Amendments to the Drawings

REMARKS/ARGUMENTS1. Drawings

FIG. 4

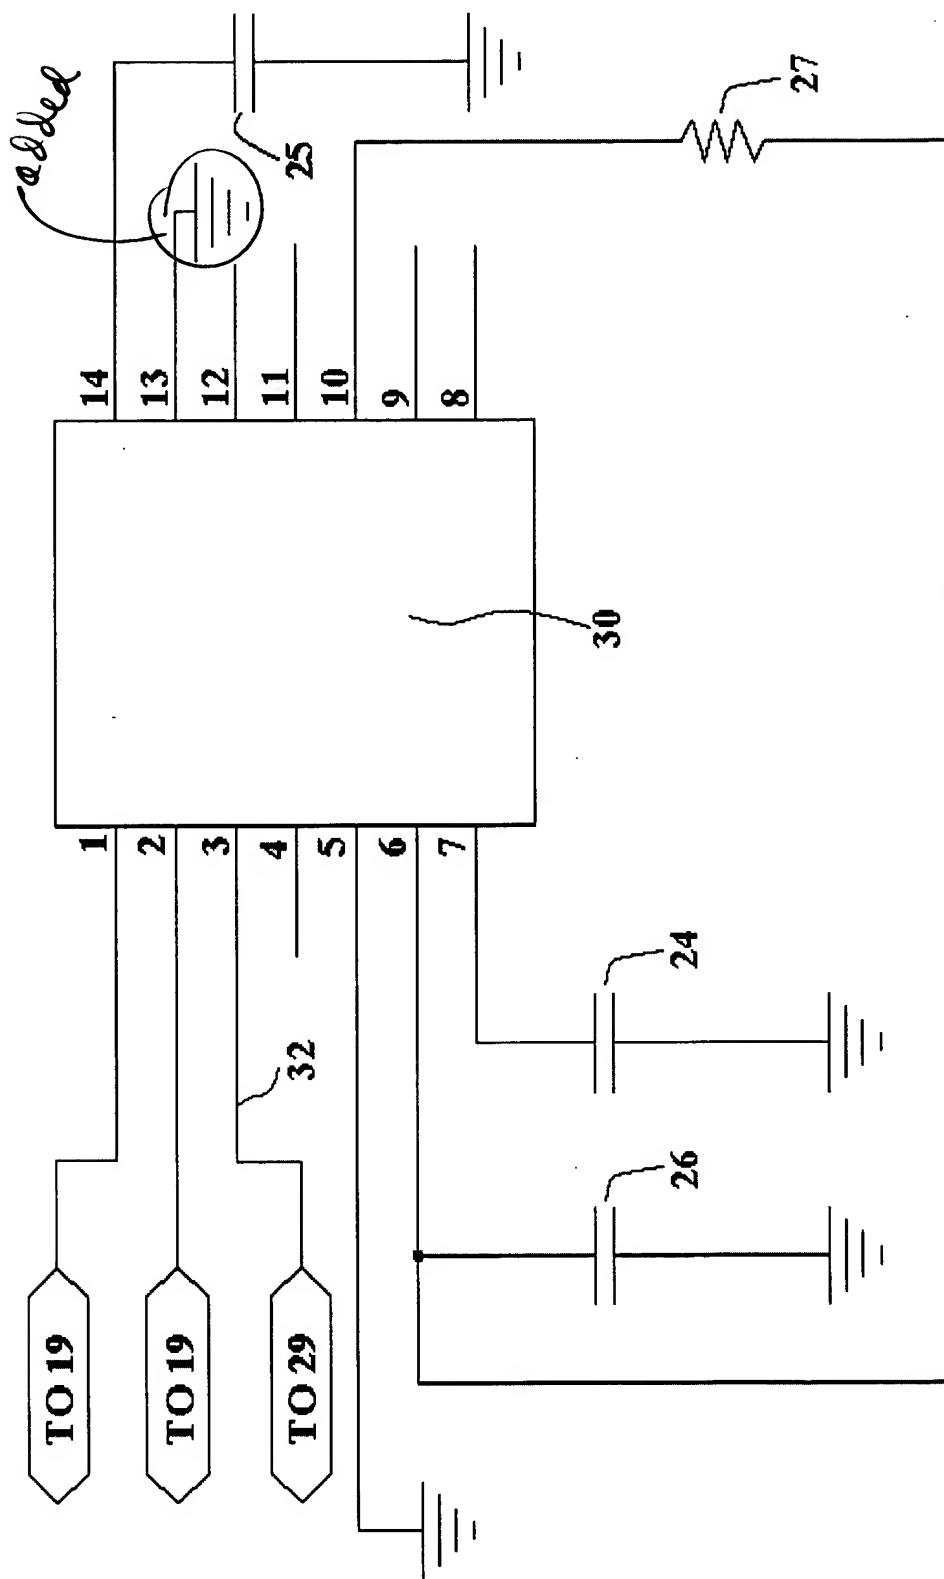
The attached drawing sheet includes a change to Fig. 4. The sheet includes only Fig. 4, the original of which it replaces. Per the objection made in the Office Action, this figure has been revised to include a depiction of the grounding of pin 13.

As noted above, Fig. 4 has been revised to include a depiction of the grounding of pin 13, per the objection made in the Office Action.
